Job Title  
**York Potash  
Proposed Minehead  
Site Preparation**

**Highway Improvements 12  
Provision of laybys on A171  
Pavement and Kerbing**

Your ref: NYM/2016/0305/CVC

Proposed: Verification check of **Condition 37** of planning approval NYM/2014/0676/MEIA  
Location: Dove's Nest Farm & Haxby Plantation, Sneatonthorpe(proposed minehead);  
Applicant: York Potash Limited

Scale at A1: 1:200  
Discipline: Highways  
Job No: 234376 Drawing Status: For Approval  
Drawing No: YP-P4-OSH-CH-160 Issue: 0

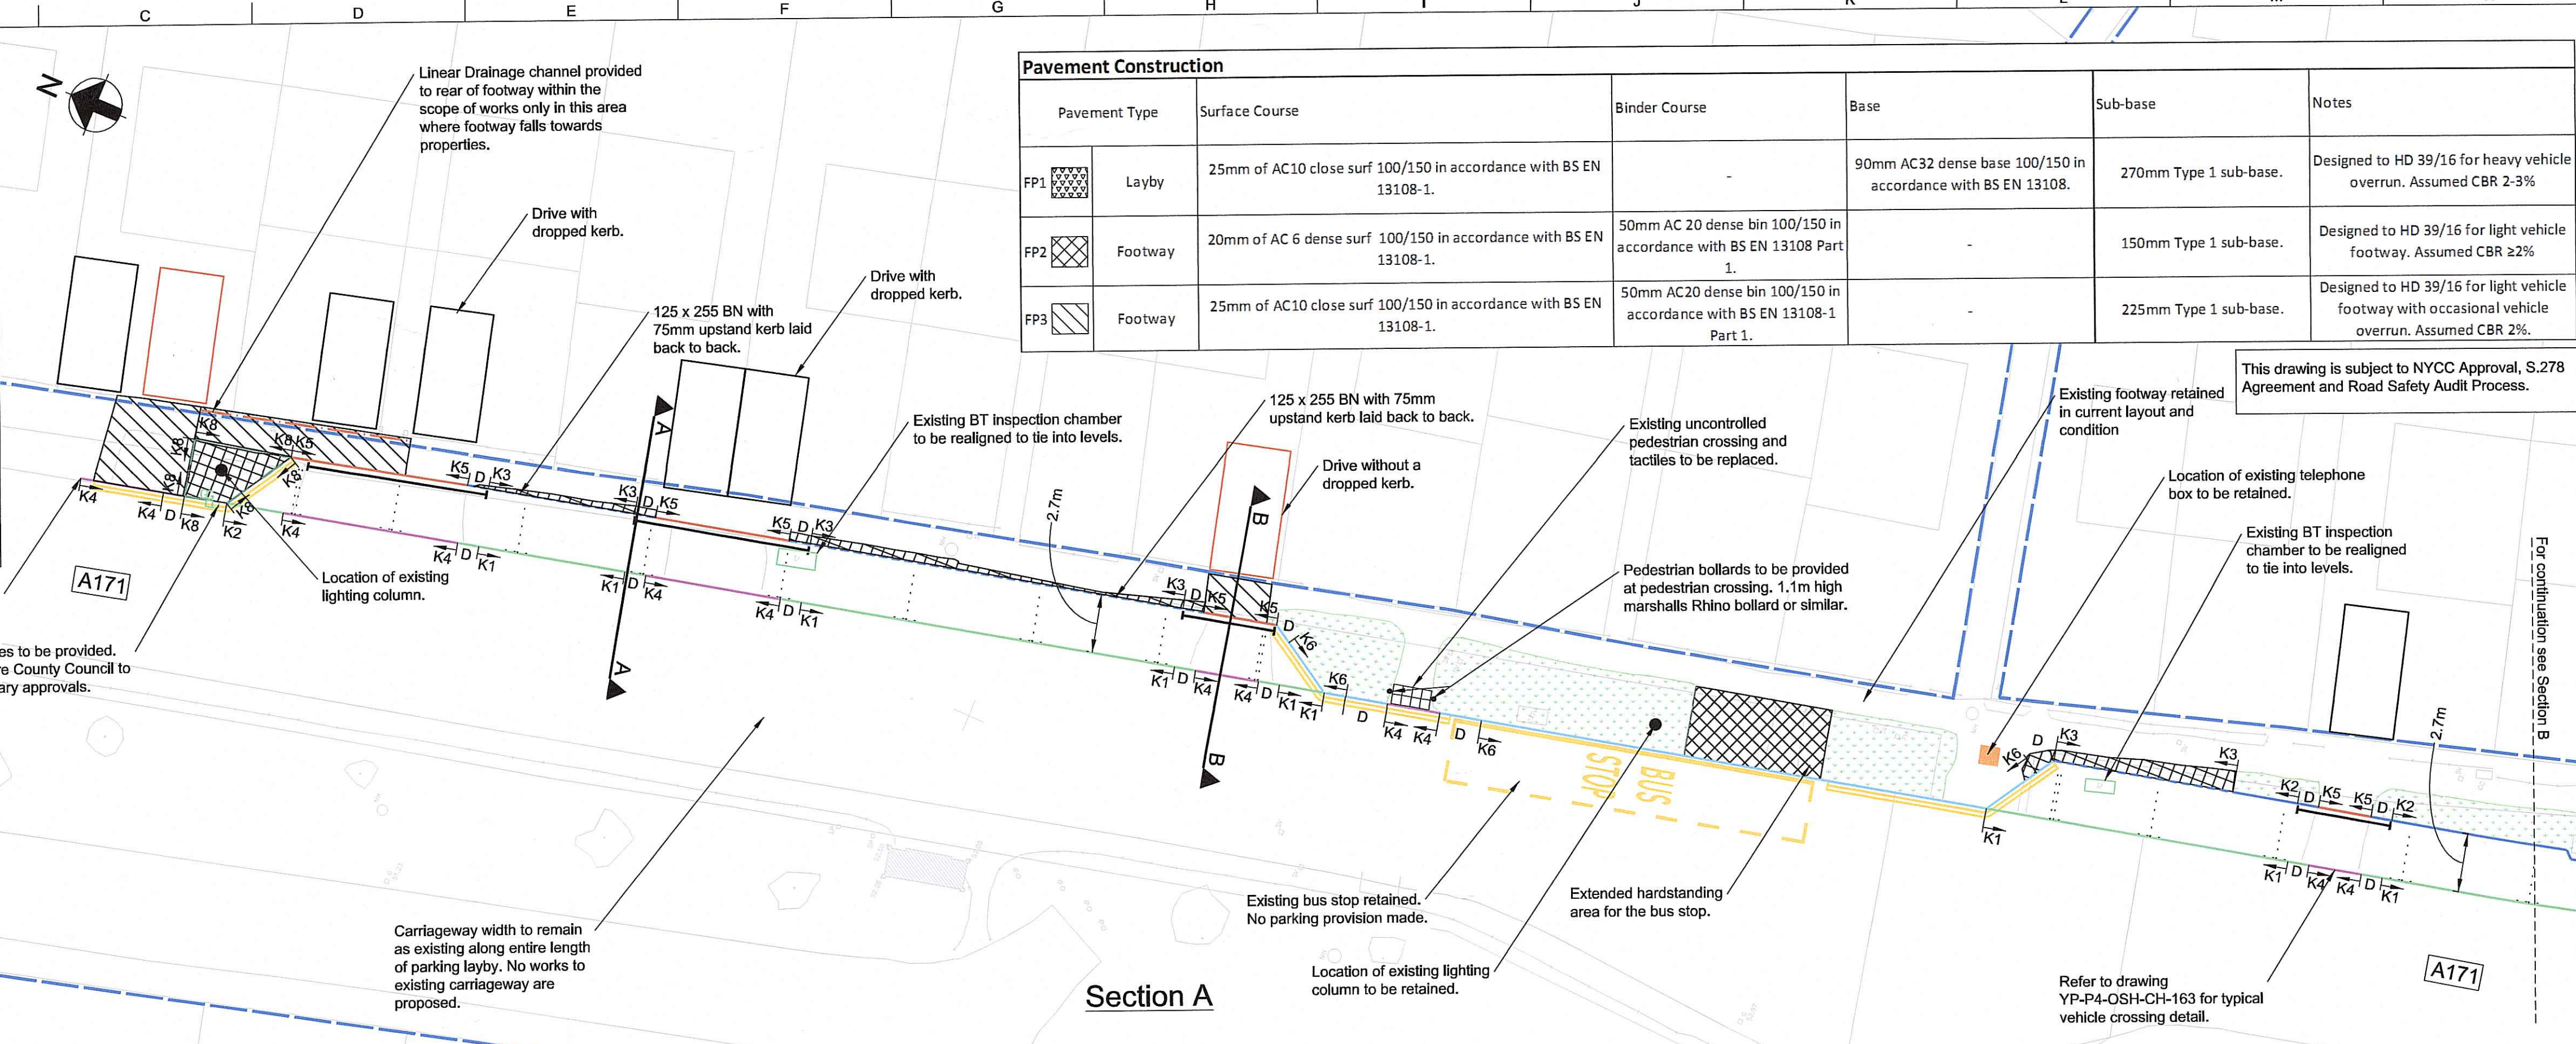
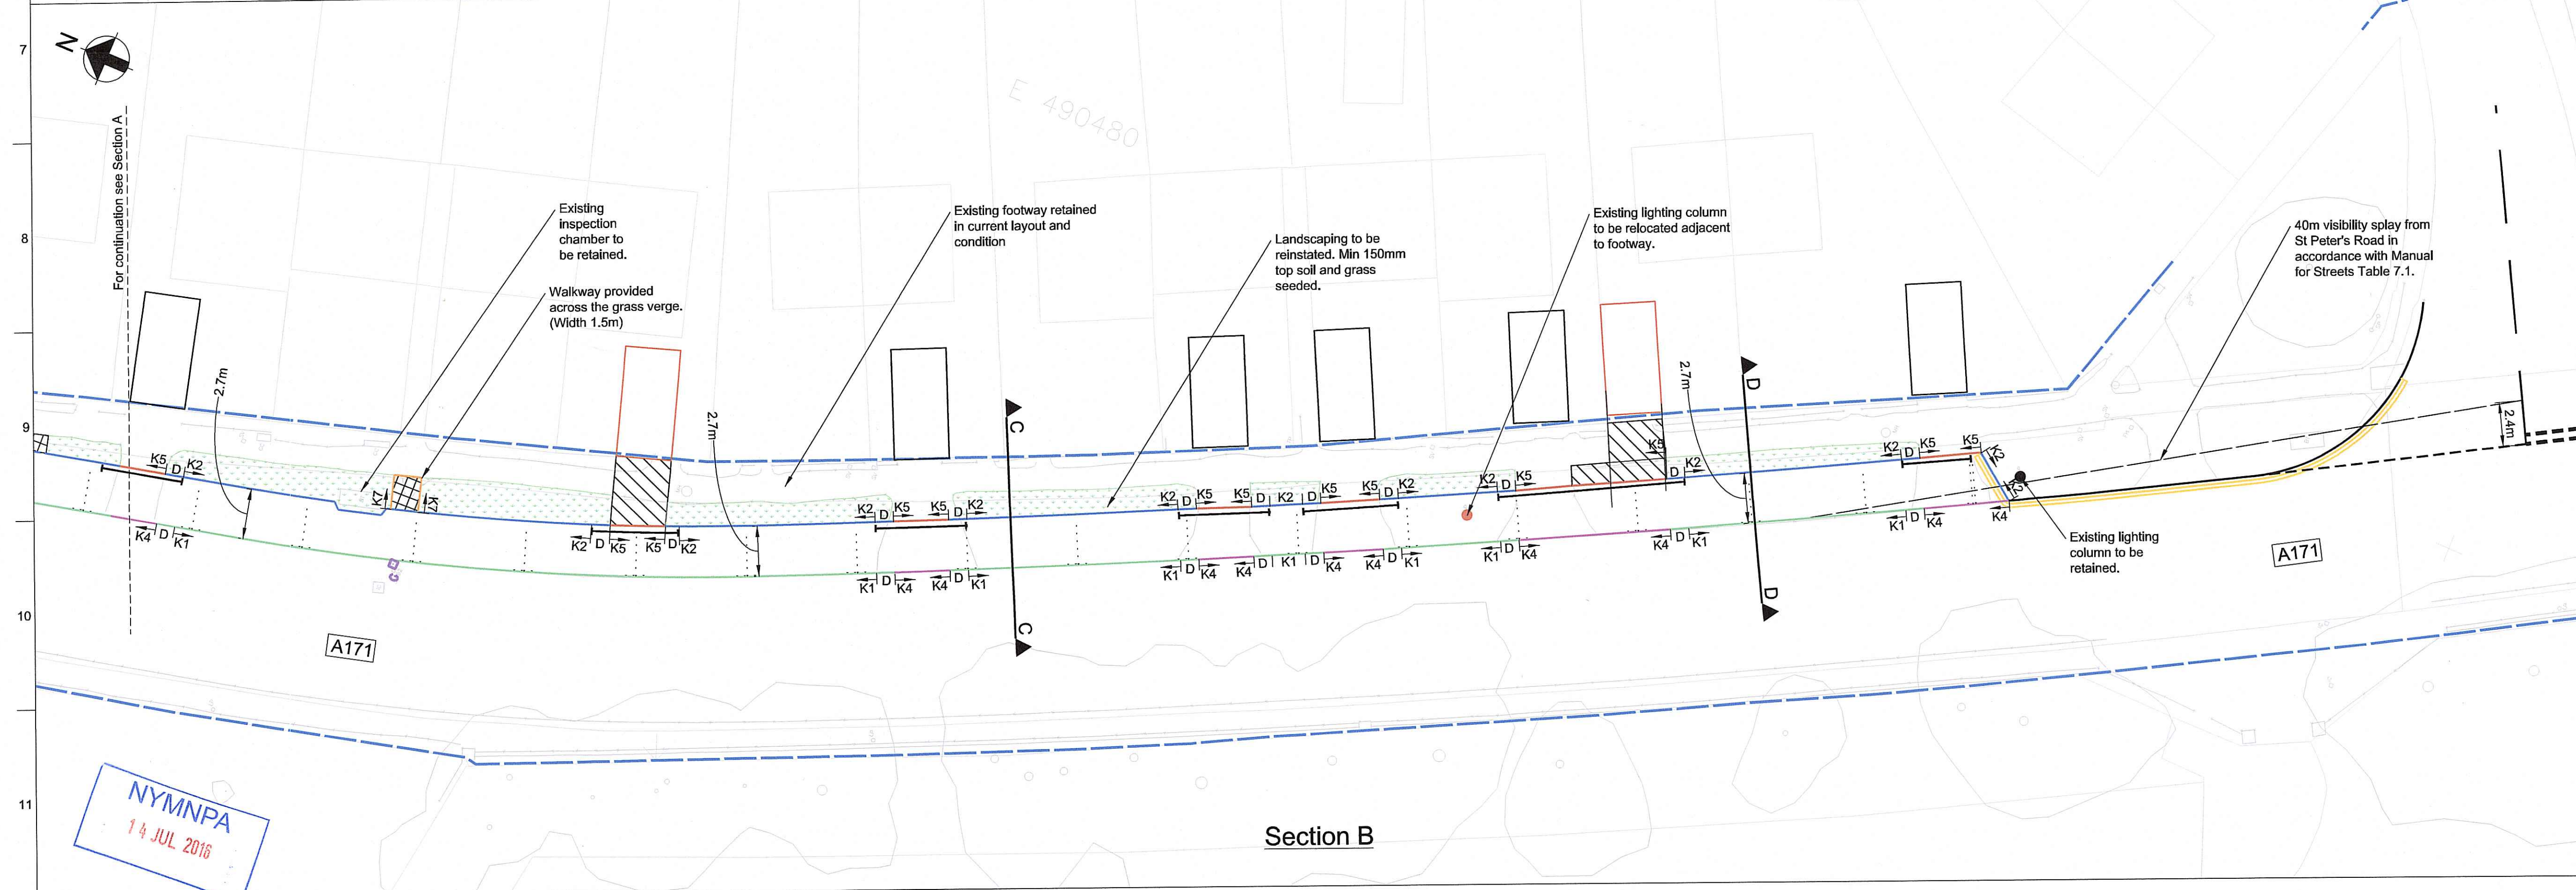
- On the A171 at the junction of the A171 and C82
- on the C82 between the A171 and Egton village
- at the parking bays on Helredale Road as indicated on ARUP drawing 234376-OSH-CH-160 issue 0. Whilst it is appreciated this drawing has not been submitted through the planning process it clearly show the intent to introduce 'double yellow line' no parking restrictions. I have attached a copy for your convenience.
- On the A171 at Normanby Bends
